Determination 2019/049

The refusal to issue a code compliance certificate for a 20-year-old house with monolithic cladding at 30 Firth View Road, Thames

Figure 1: Approximate site plan

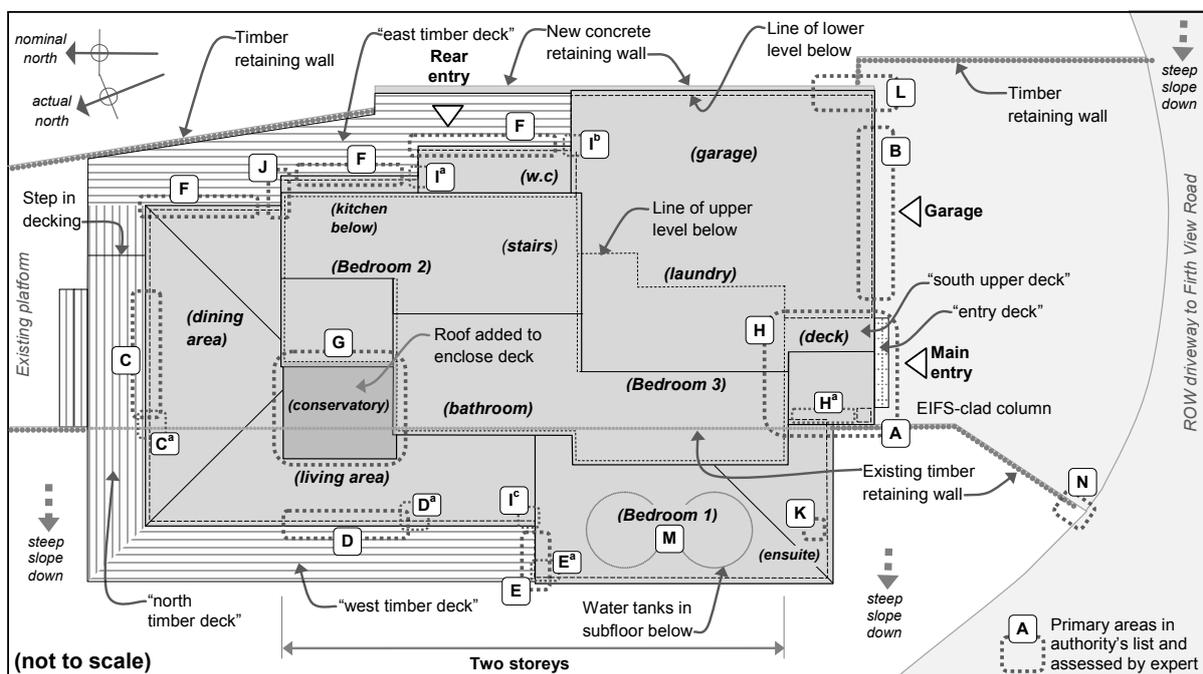
5.2.1 The expert noted that ‘the overall architectural shape and form of the building’ (see Figure 1) appeared ‘largely in accordance with the consented drawings’. The expert observed the following discrepancies:

Elevated readings and signs of damage were recorded as follows (with locations as per Figure 1 shown in brackets):

- 96% and heavily decayed flooring at the north deck doors (Area C^a)
- 20% in water stained floor joist below the above (Area C^a)
- 91% and decayed flooring and bottom plate at the west deck doors (Area D^a)
- 18% in water stained flooring beside Bedroom 1 deck door (Area E^a)
- 19% in soffit framing below the south upper deck (Area H^a)
- 27% in framing below the end of the east apron flashing (Area J)
- 18% in skirting beside the ensuite shower cubicle (Area K).

5.3.2 The expert carried out further investigation by removing carpet, underfloor insulation and accessing subfloor/ceiling spaces in a number of areas as follows (see Figure 1):

5.4 The expert addressed the authority's reasons for refusing to issue a code compliance certificate outlined in its letter dated 13 July 2010; and paragraphs 5.5 to 5.11 summarise his findings (with references and associated areas per Figure 1 provided in brackets).

- inadequate clearances between the cladding and the ground at the garage and front entry (Areas A and B)
- inadequate clearances between the cladding and timber deck (Areas C to E)
- in regard to the EIFS-clad balustrade to the south upper deck (Area H^a):
 - the height of the balustrade is insufficient
 - the balustrade cap flashing lacks a slope
 - there is a leak into the soffit framing below the balustrade
- leaking apron flashing/gutter junction north-east kitchen corner (Area J).

6.2.6 I consider that the expert has found sufficient evidence to show that a number of areas require significant attention. Taking account of the expert's report, I am satisfied that the following areas require further investigation and repair:

- cladding clearances at the garage and front entry (Areas A and B)
- cladding to timber deck clearances (Areas C to F)
- the inadequate height of the EIFS-clad balustrade (Area H^a)
- investigation and repair in regard to moisture penetration at:
 - soffit framing below the clad west balustrade (Area H^a)
 - framing below the east apron flashing/gutter junction (Area J)
 - framing and flooring adjacent to timber decking (Areas C to E).
